Re: Extension of Duration - ABP-308002-20E

1. I am writing in relation to the Extension of Duration application for 413 unit residential development at Carcur-Park, Wexford Town original planning file ref ABP-308002-20, extension is ABP-308002-20E.
2. The application details are summarised on the Wexford County Council planning website. (**Attachment 1 - Citizen Portal Planning - ABP-308002-20E**).
3. I note the final day for third party observations/submissions is the 6th February 2026 and accordingly the following are my observations/submission.

***Proposed Road Overbridge at Carcur, Wexford
Acceptance in Principle with conditions***

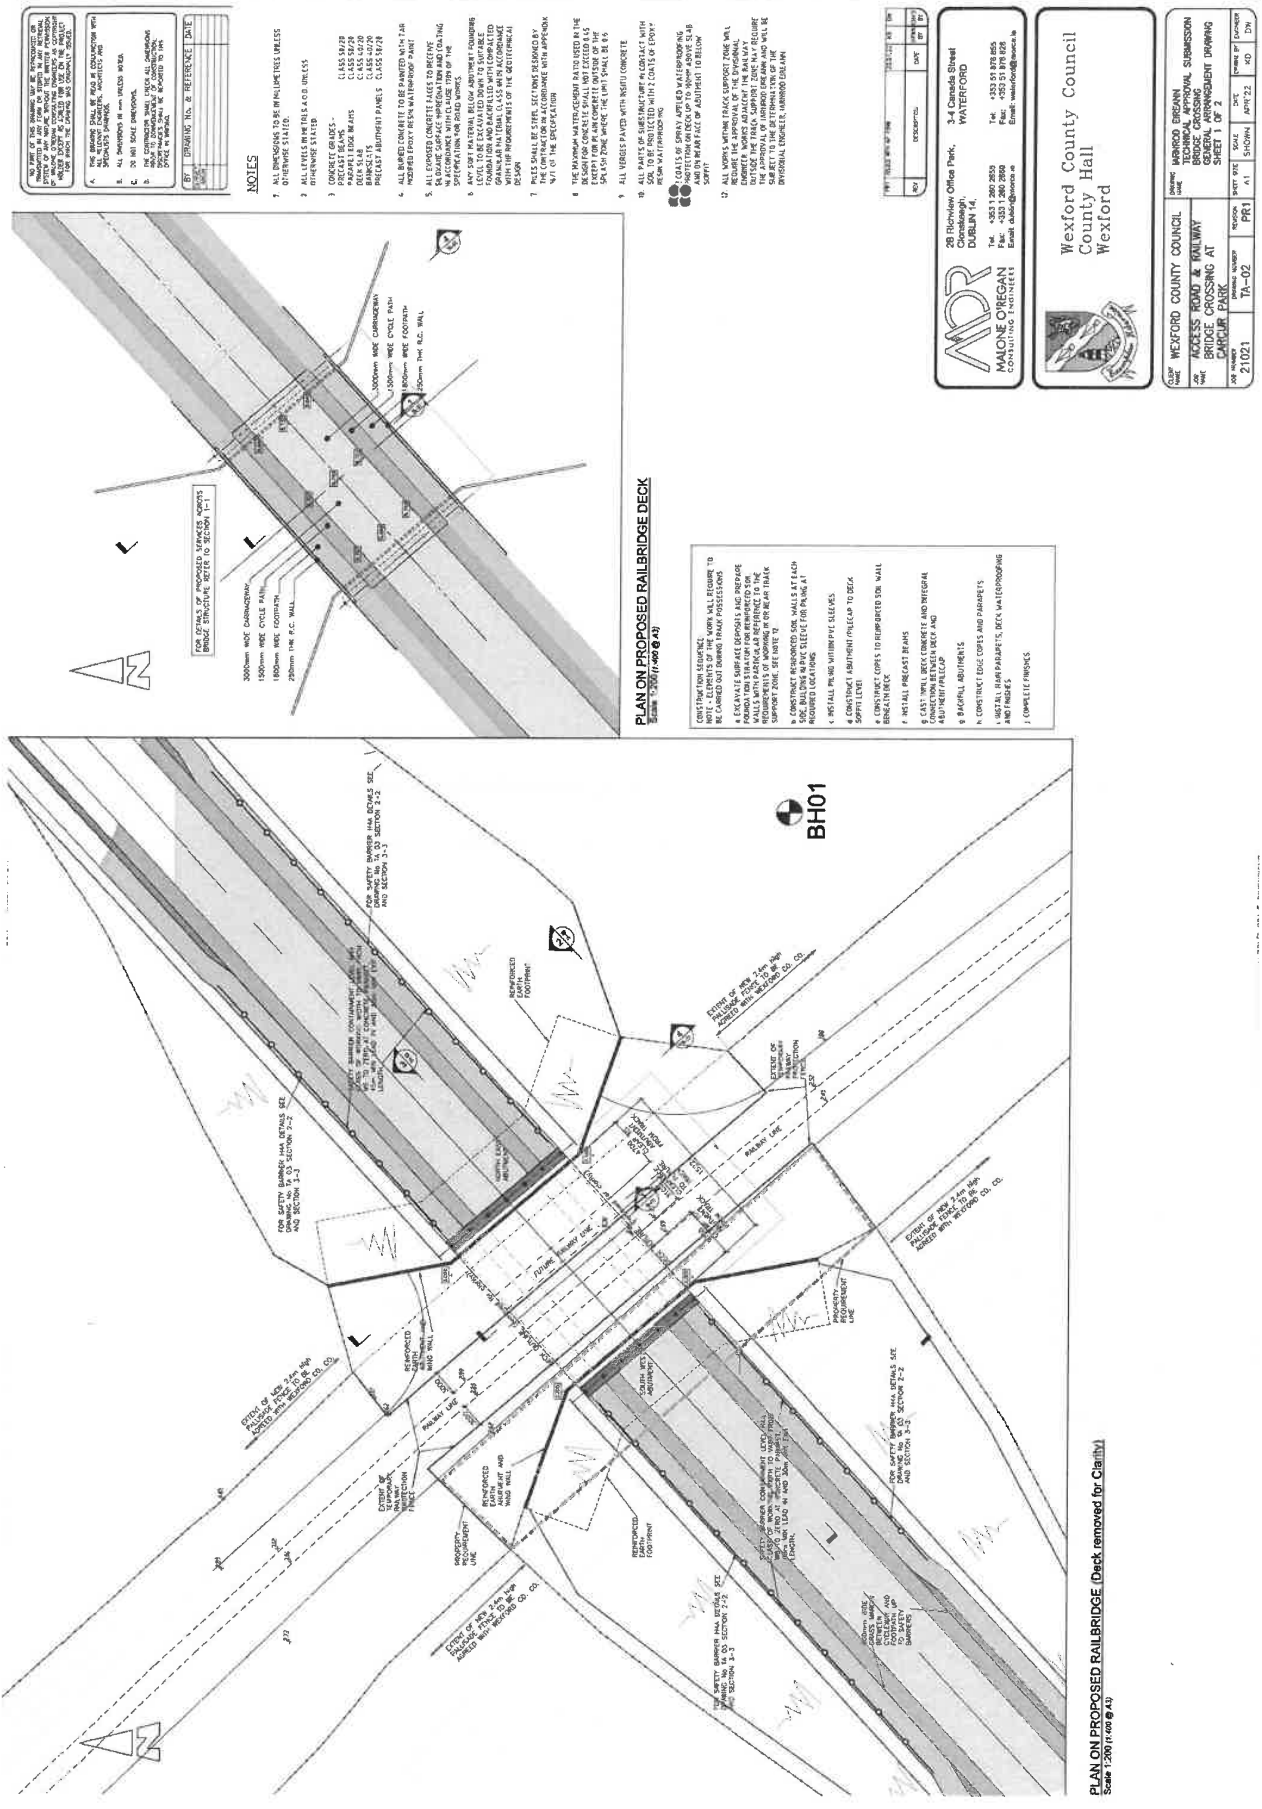
21. It is clear from the design drawings that the carriageway is a total of 6.0m wide and is not compatible with the wider carriageway on the existing inner relief road from Newtown Road to the Seamus Kelly Roundabout.

22. If the bridge has been built in compliance with the drawings approved by CRR then the carriageway width of 6.0m will not facilitate an extension of the inner relief road over the railway line.
